**JEA Brandy Branch
Combined Cycle Conversion**

**JEA-Brandy Branch
Sufficiency Response**

Re: JEA-Brandy Branch Conversion Project
Site Certification Application
FDEP File No. PA 00-43
DOAH Case No. 00-5120EPP
OGC Case No. 00-2321
Response to Statement of Sufficiency

MODFLOW Simulated Changes in Water Table at the Center of the Wellfield.
Changes Due only to the downward gradient between the Water Table and the Upper Floridan Aquifer.

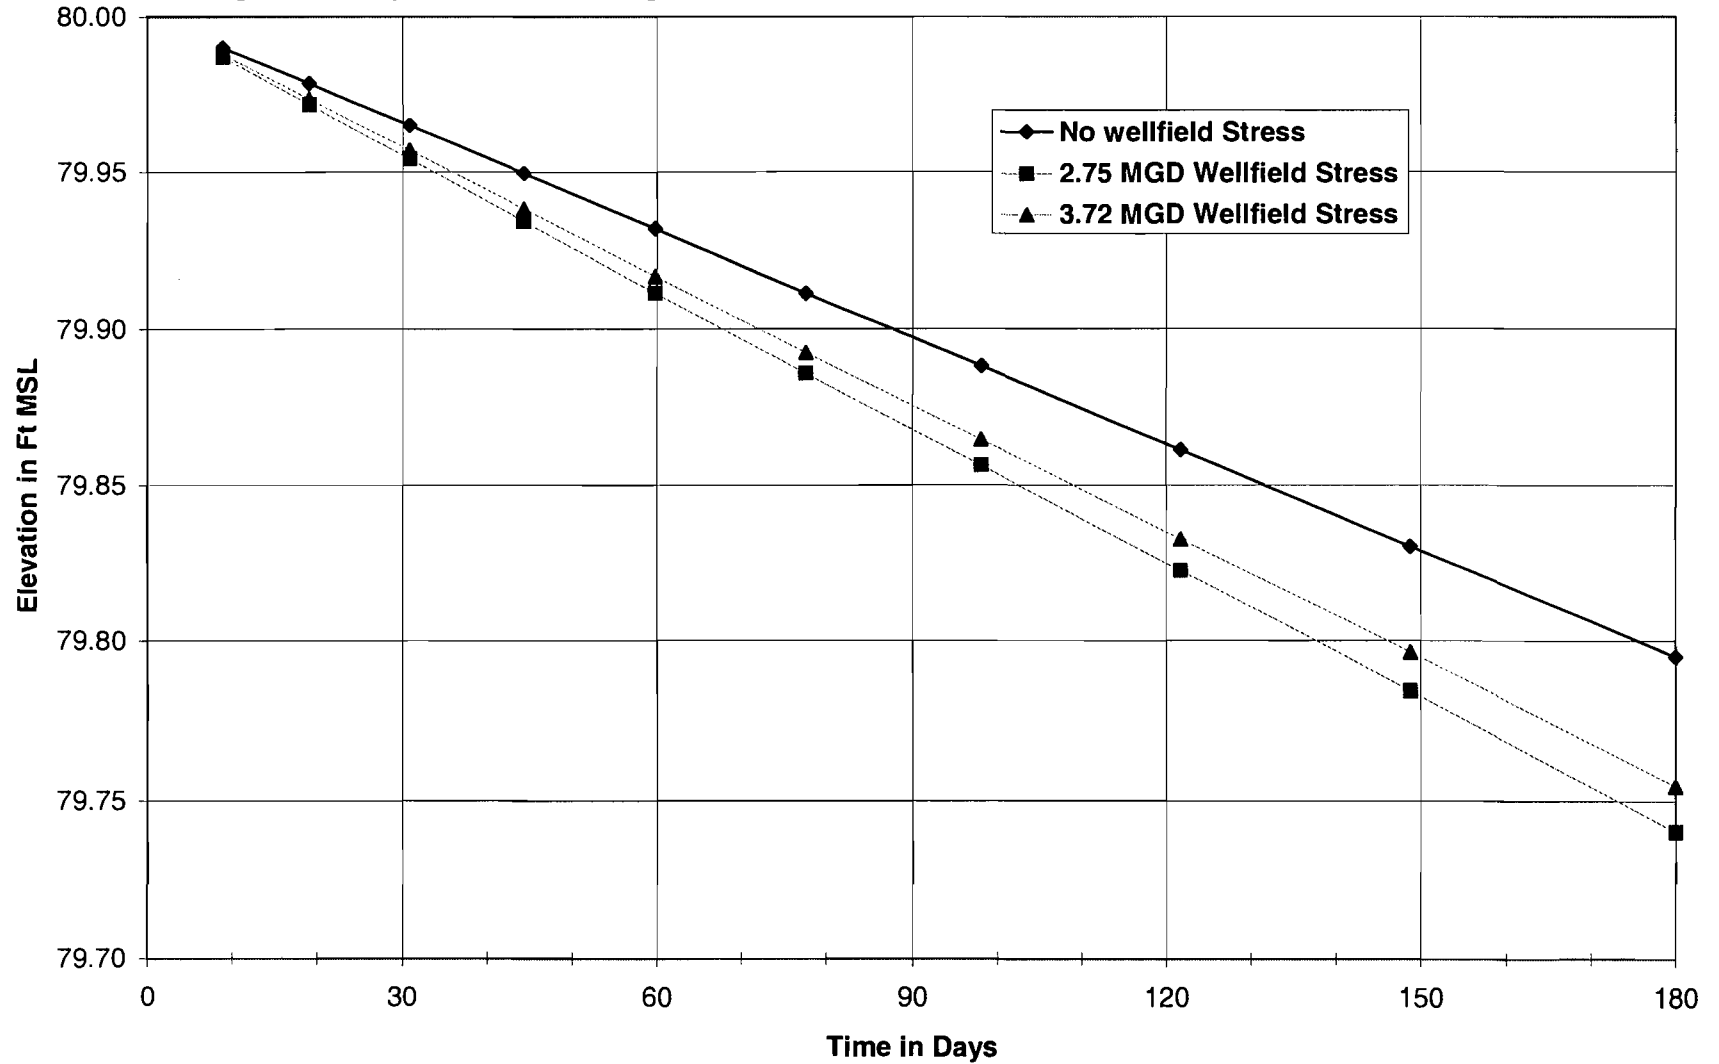
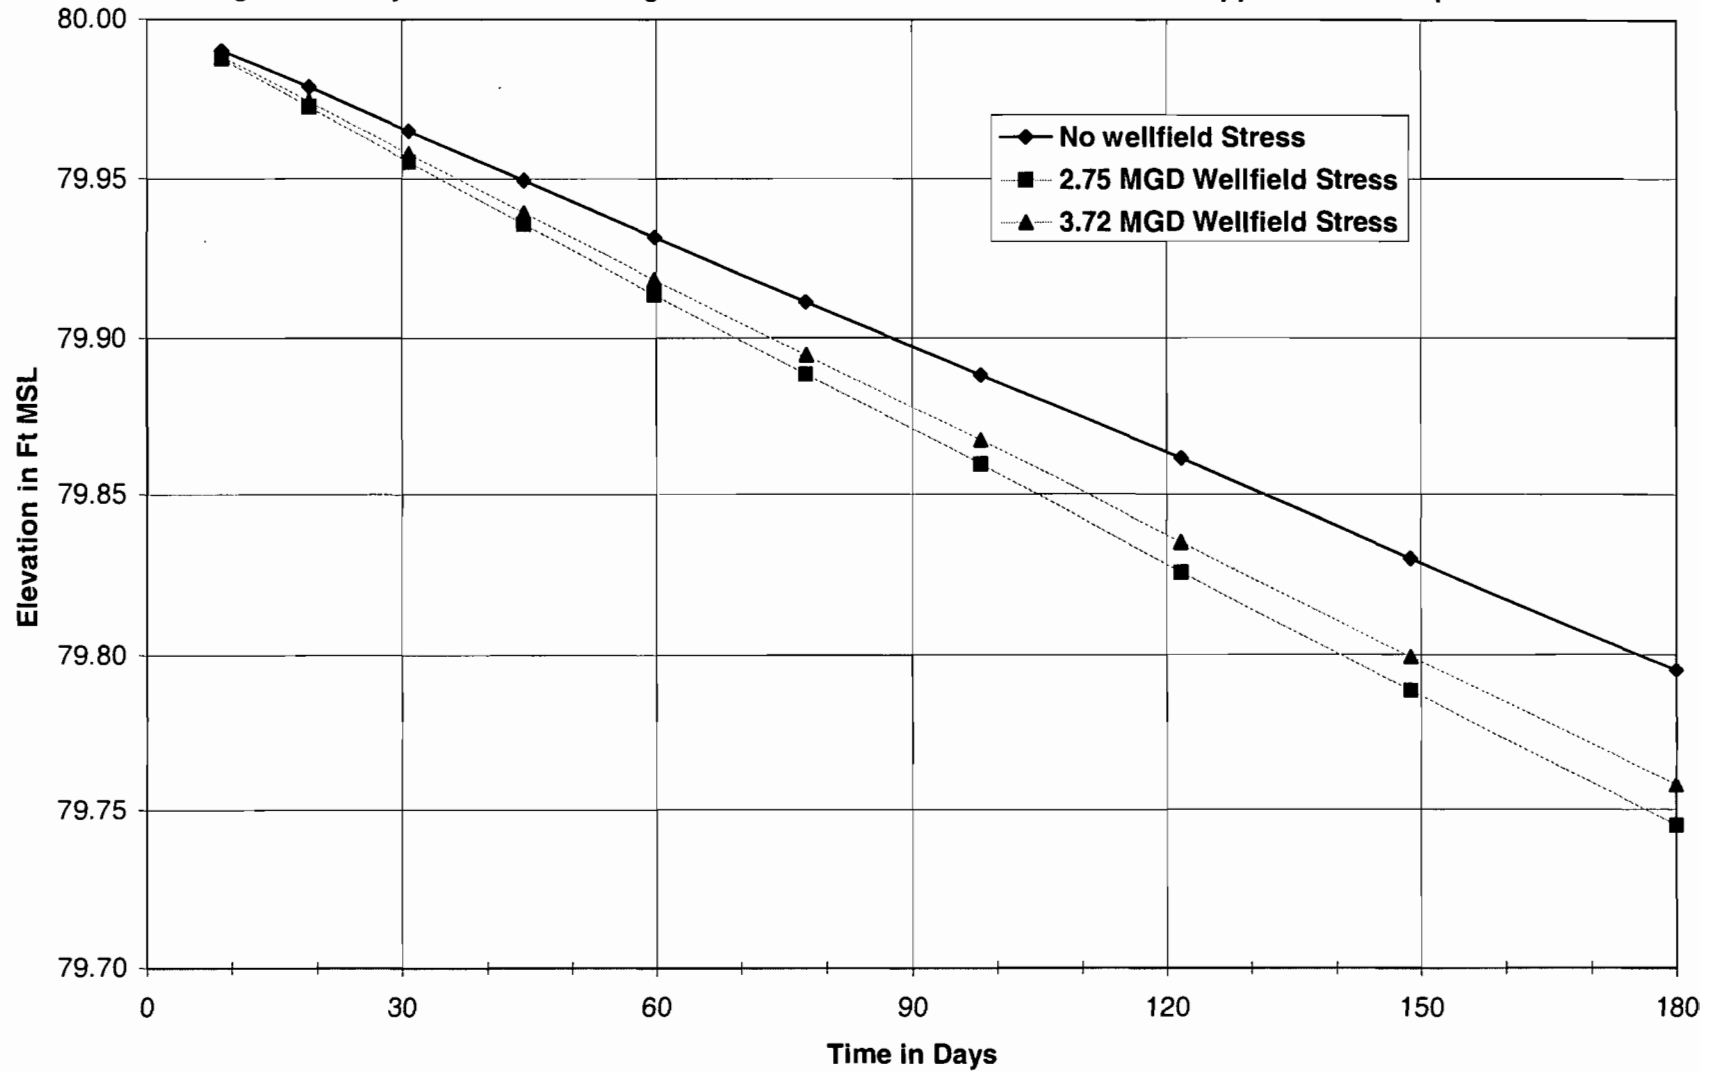
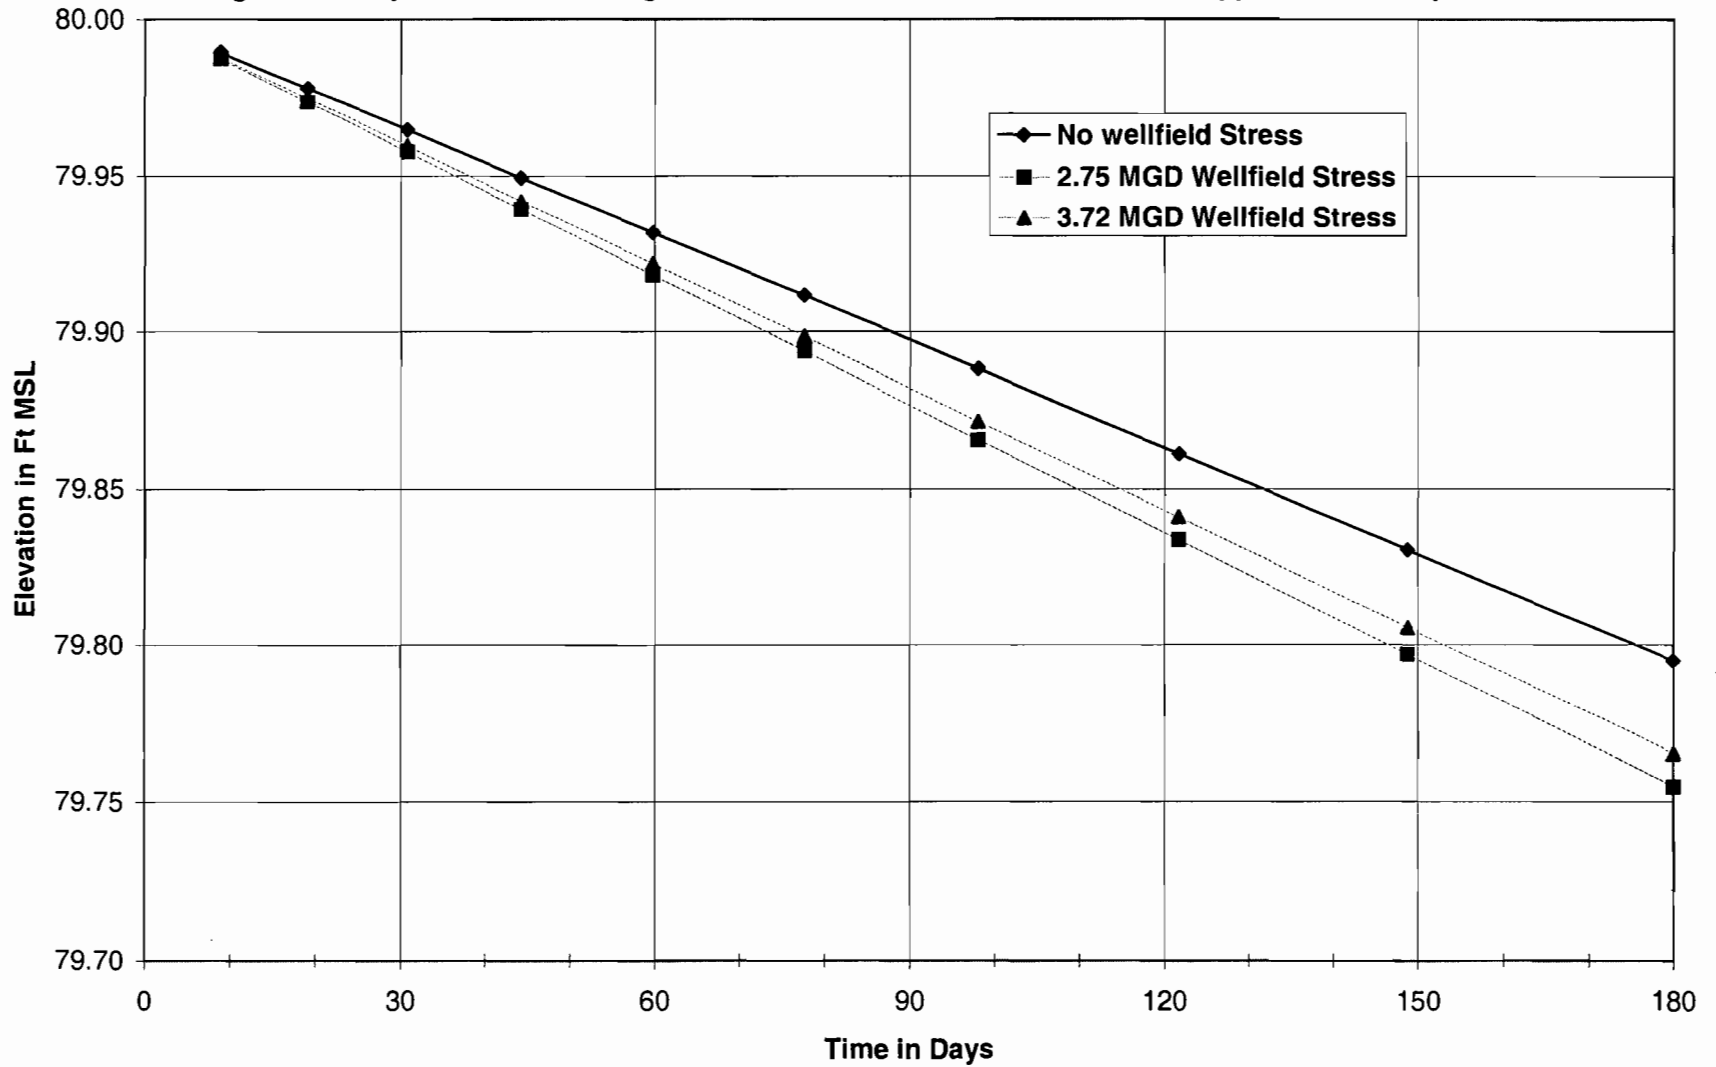
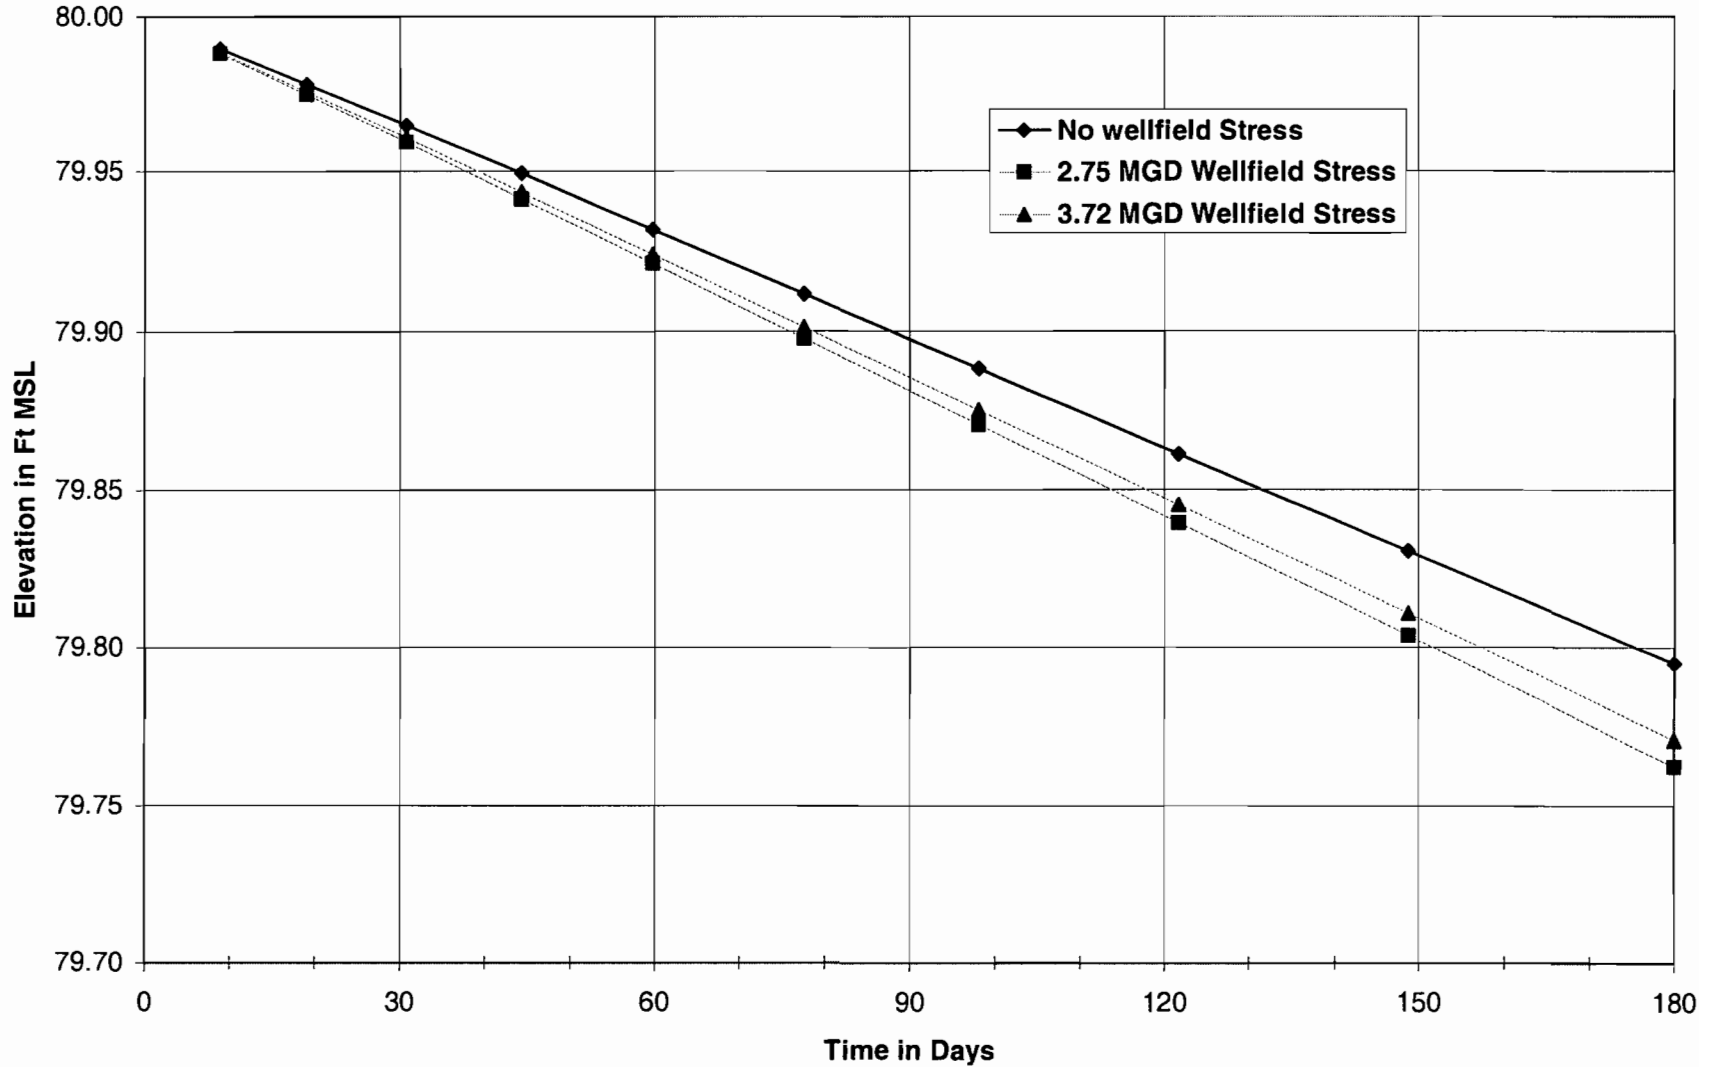
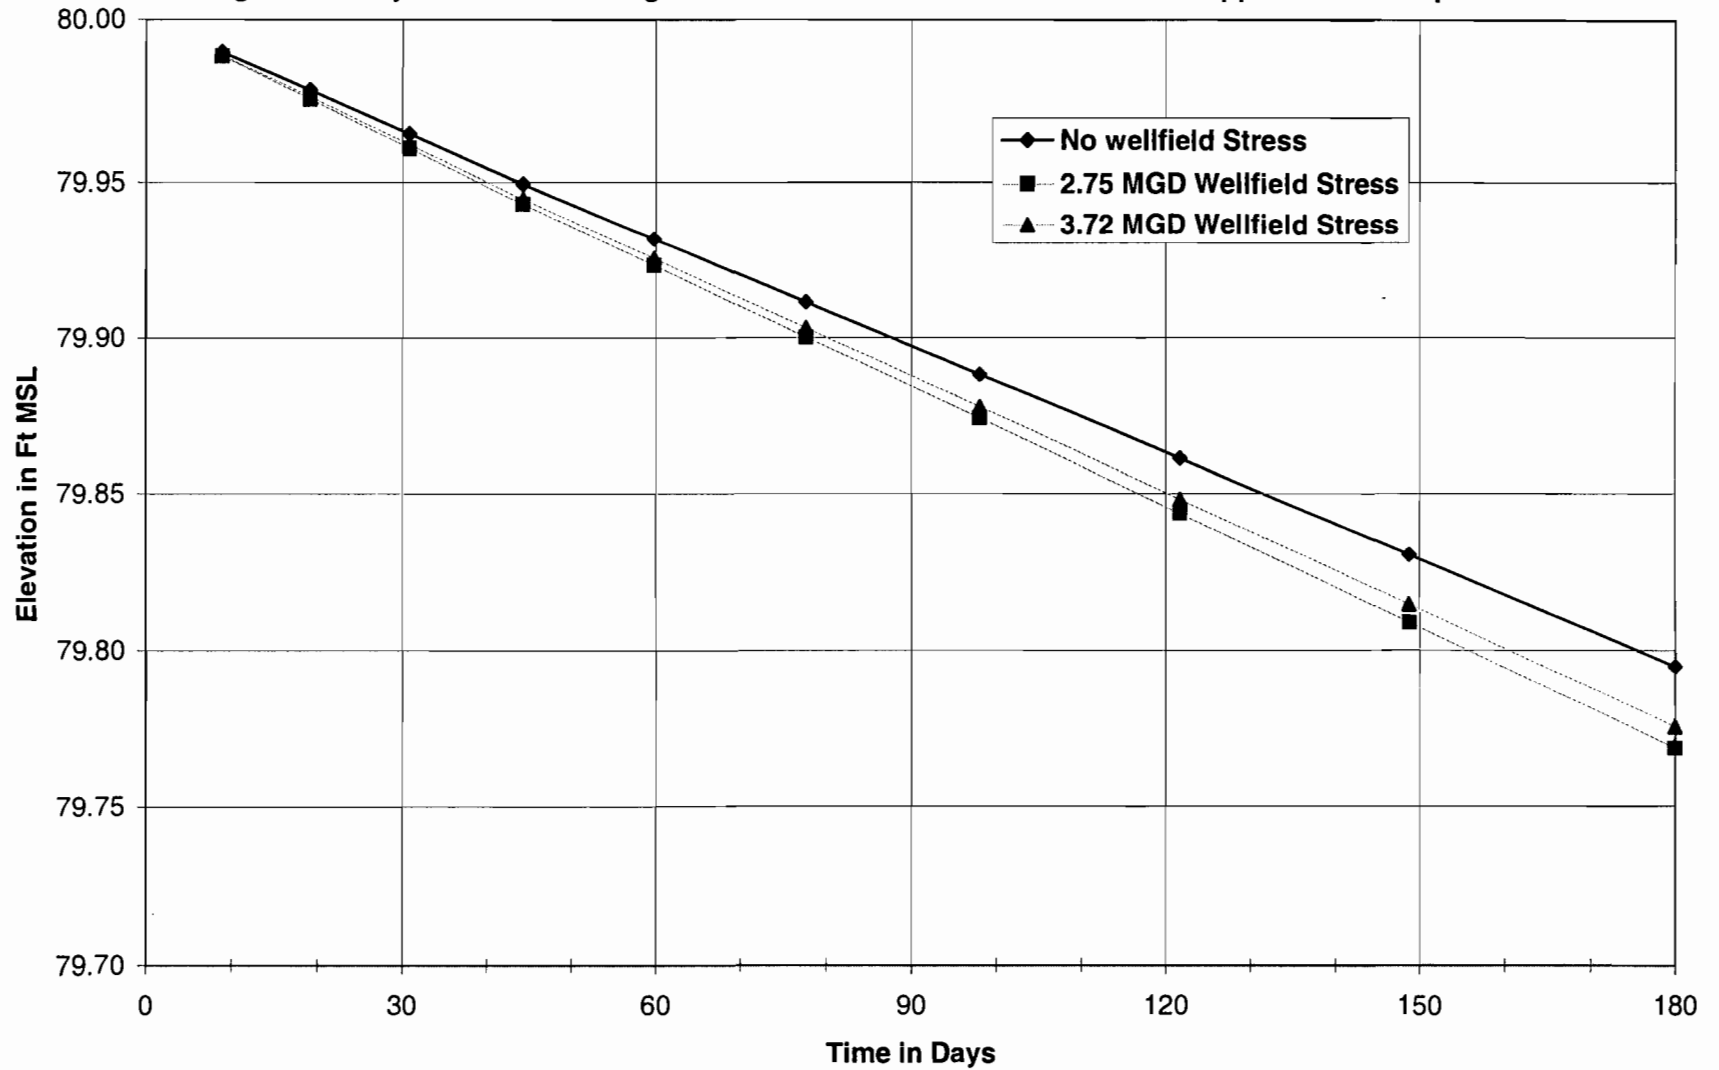
1. *The application indicates that there are herbaceous and forested wetlands as well as other surface waters on and surrounding the proposed site. The ground water modeling, however, analyzes the drawdown impacts to the Floridan aquifer only. Please provide an analysis of the steady-state impact of the proposed Floridan aquifer withdrawals on the surficial water table at the maximum proposed pump rate of 2.744 million gallons per day (mgd) and at increased rate of 3.722 mgd for 288 hours, transient conditions. The drawdown contours should be overlain on a map of wetlands and surface waters and displayed at one-half foot intervals and also delineate outward from the well(s) to the 0.2 foot drawdown contour. [Section 10.2(e)(f)(g)(l)(p), 10.3(d), Applicant's Handbook Consumptive Uses of Water (February 8, 1999) (A.H.)]*

Exhibits 8-A through 8-H show time series graphs for a 180 day period at the center of the wellfield, and at distances of 1,000 ft, 2,000 ft, 3,000ft, 4,000 ft, 5,000 ft, 7,500 ft, and 10,000 ft from the center of the wellfield. The baseline scenario with no wellfield pumping is identical regardless of the distance from the wellfield. This baseline drop in water table elevation amounts to 0.21 feet over the 180 day period or 5.1 inches per year, comparing well with the simple calculation of the previous paragraph. At the center of the wellfield the 2.75 MGD scenario added an additional 0.04 ft (0.48-inch) to the baseline scenario after 180 days and the 3.72 MGD added an additional 0.05 ft (0.60-inch) to the baseline scenario after 180 days. Using a 90 day period, the two pumping scenarios added an additional 0.02 ft (0.24 -in) and 0.025-ft
